SERVICE BULLETIN

SB025-495

Subject: Lancair IV flap track attachments

Ref: Page 9-30 (rev A10)

Figure 9:B:11

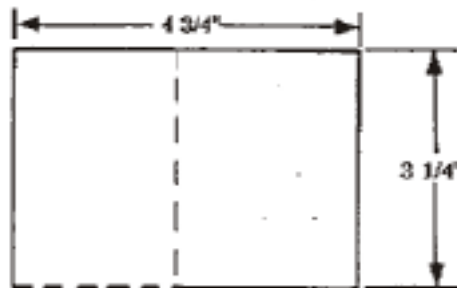
During inspection of the flap tracks on our prototype, a slight movement was detected which was traced down to the 12 BID attachment on each side of the track. The base area was showing signs of minor delamination thus an installation construction change is required.

This change is in the form of an additional 10 BID attachment which lays over the original and ties the original to the lower wing skin area (similar that the way the original ties to the upper wing skin area). Below are revisions (rev 10) for the manual which describes this change.

- B19. Support for the flap tracks is mentioned back in Chapter 7, page 7-27. Notice in Figure 9:B:11 the dimensions for cutting the 10 BID.

10 BID Support Pattern
